IREDELL COUNTY HEALTH DEPARTMENT

IMPROVEMENT PERMIT / AUTHORIZATION TO CONSTRUCT / OPERATION PERMIT / EXISTING SYSTEM

LAKEMIST HOMES SEPTIC SITE PLAN
12-7-16

Reference: **Technical Assistance with Septic Permitting**
Lot 54 Woodleaf Subdivision
324 Kenway Loop
Iredell County, North Carolina
Project No. 16-160

AS BUILT SKETCH

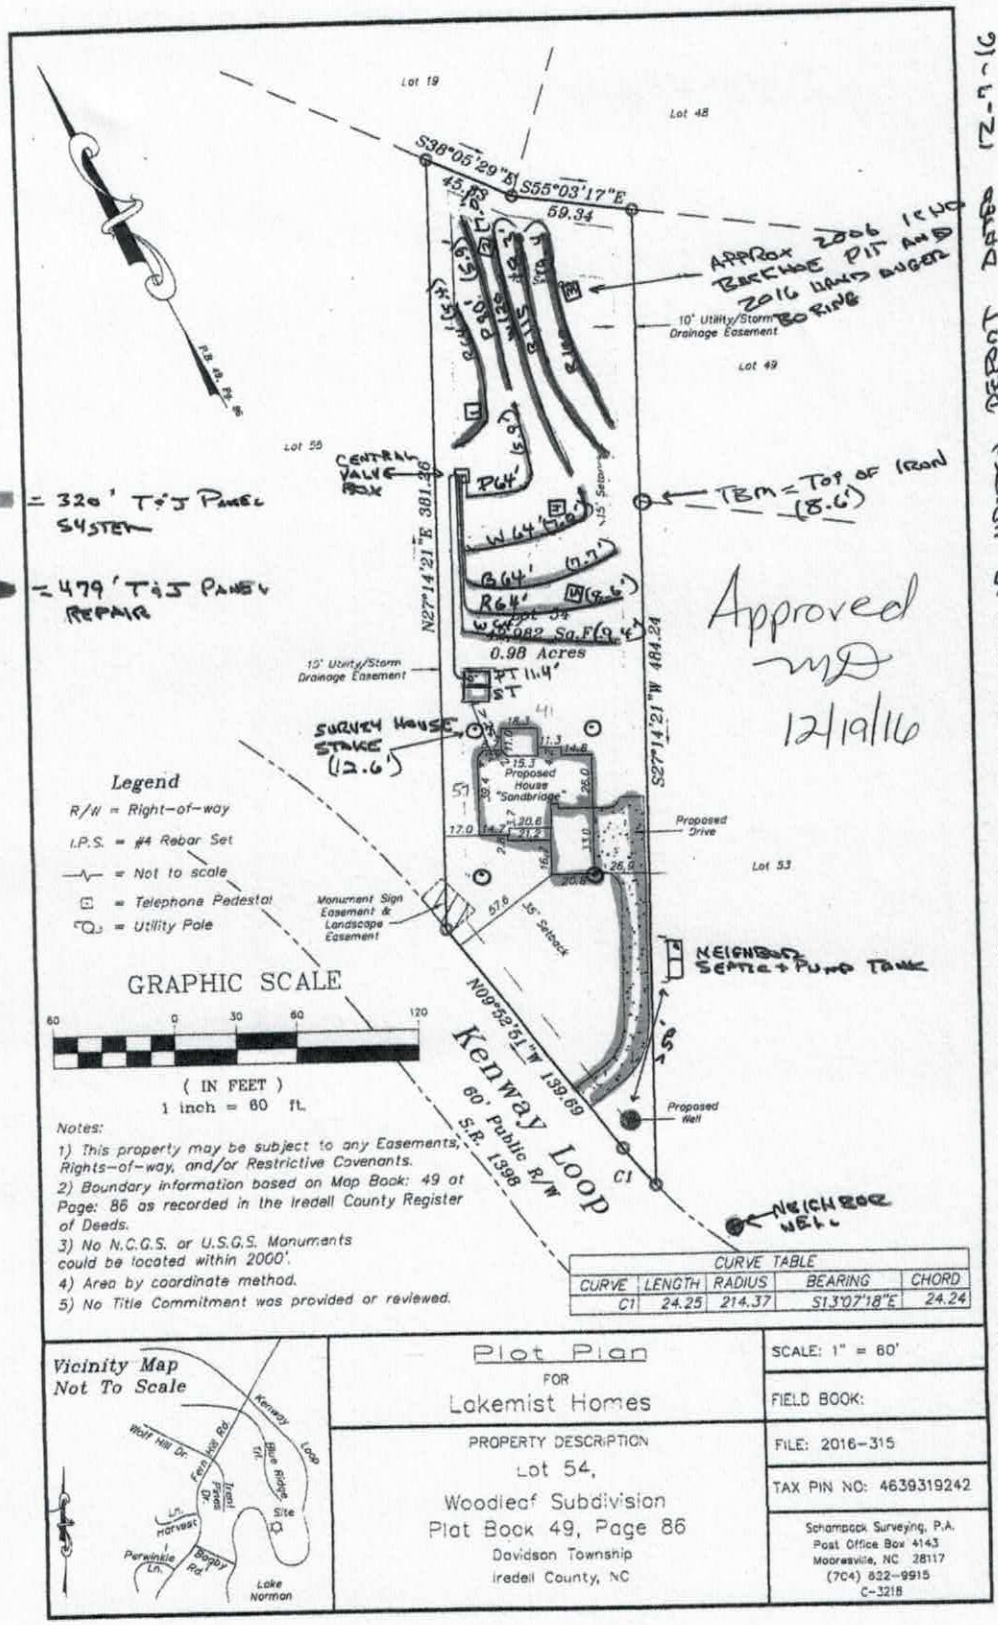
6/16/17: 2' of head set on each of the 5 lines. 5.5" feather on the on/off float delivering ≥ 170 gallons/dose. Mastic/tar needed + installed in control box. Separate circuits for alarm/pump (inside house) OK

LAKEMIST HOMES SEPTIC SITE PLAN

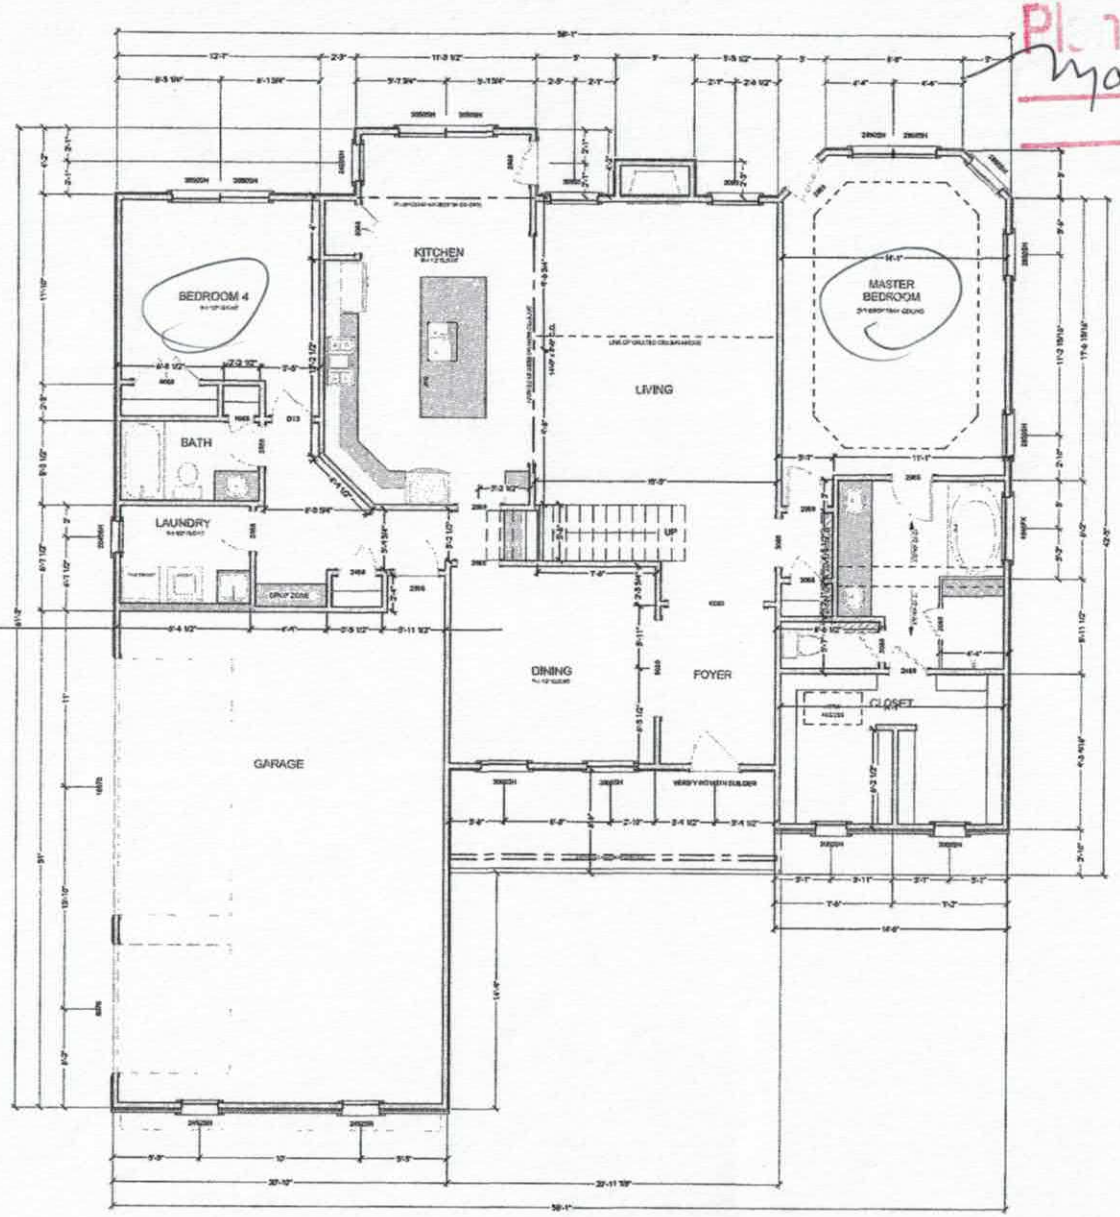
4 SITE PLAN MUST ACCOMPANY PENNINGTON SOIL CONSULTING WRITTEN REPORT DATED 12-7-16
